Our reference: 1710-2156 SRA
Your reference: CA2275/2017

Referral agency response—with conditions

| Street address: | 49 Macrossan Street (Port Douglas Road), Port Douglas |

| Development permit | Material change of use for shopping facilities, restaurant, multi-unit housing and holiday accommodation. |

| Drawing/report title | Prepared by | Date | Reference no. | Version/issue |
|--|---|-----------------|-----------------------|---------------|
| Floor Plans | TPG Architects | December 2017 | DA-100H | |

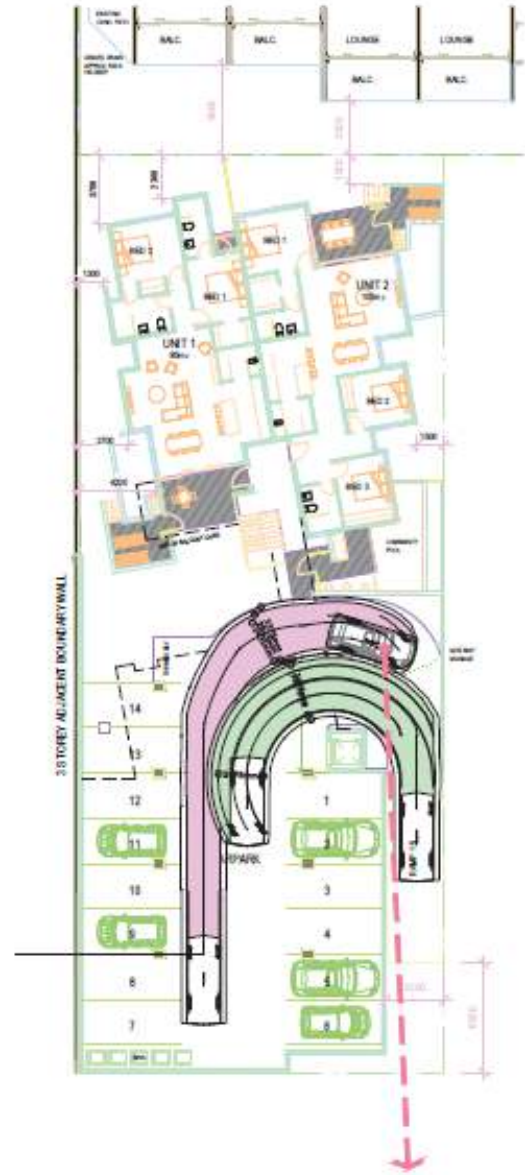
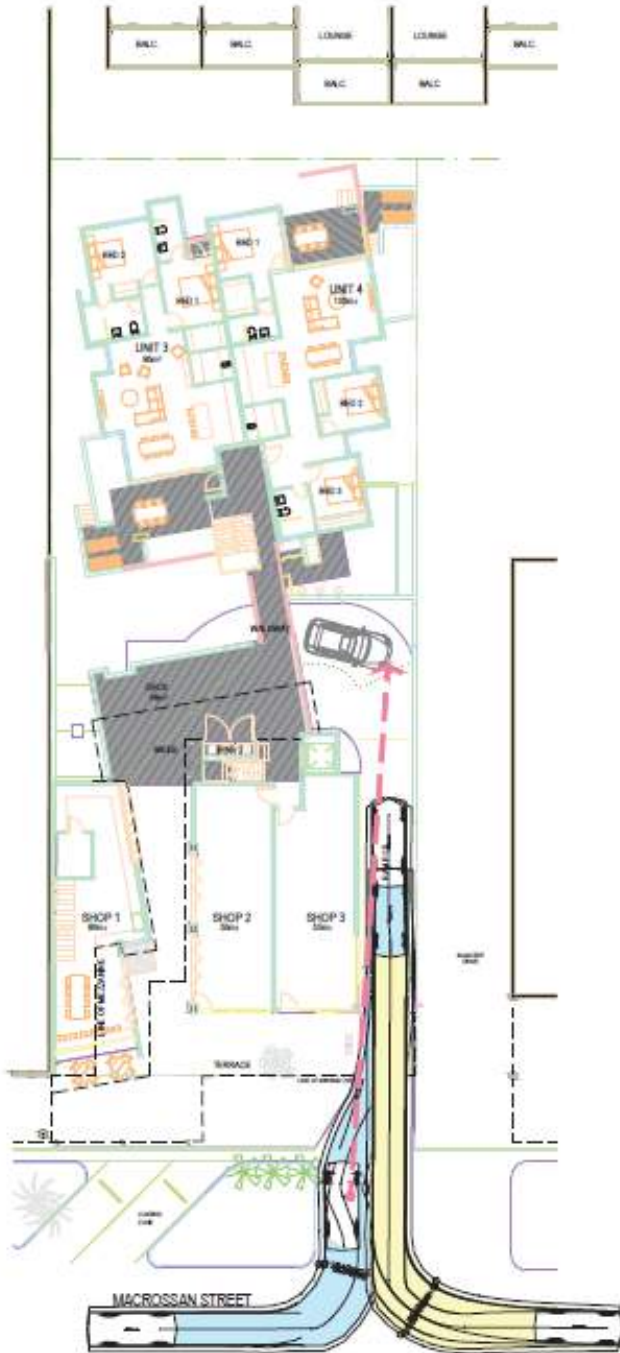
| No. | Conditions | Condition timing |
|---|---|--|
| 1. | <p>The car parking and access arrangements must be carried out generally in accordance with the following plans:</p> <ul style="list-style-type: none"> • Floor Plans prepared by TPG Architects, dated December 2017, Reference DA-100H. • Vehicle Swept Paths, prepared by C.M.G Consulting Engineers Pty Ltd, dated 4 December 2017, sheet 1 of 2. | Prior to the commencement of use and to be maintained at all times |

**TMR Layout Plan
(6504 - 5.49km)**

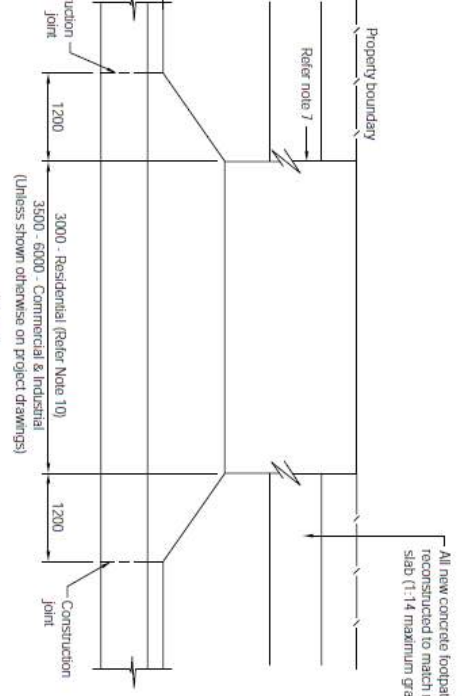
| No. | Conditions | Condition timing |
|---|---|--|
| 2. | <p>(a) The road access location is to be located generally in accordance with TMR Layout Plan (6504-5.49km), prepared by Queensland Government Transport and Main Roads, Reference TMR17-22871(500-1184), dated 08/01/2018, issue A,</p> <p>(b) Road access works comprising a Commercial/Industrial Vehicle Crossing must be designed and constructed in accordance with FNQROC Standard Drawing S1015.</p> | (a) At all times (b) Prior to commencement of use |
| 3. | <p>(a) The existing vehicle property access located between Macrossan Street and Lot 410 on PTD2091 must be permanently closed and removed.</p> <p>(b) The kerb and channel, table drain and concrete footpath must be reinstated in accordance with FNQROC standards.</p> | Prior to commencement of use |
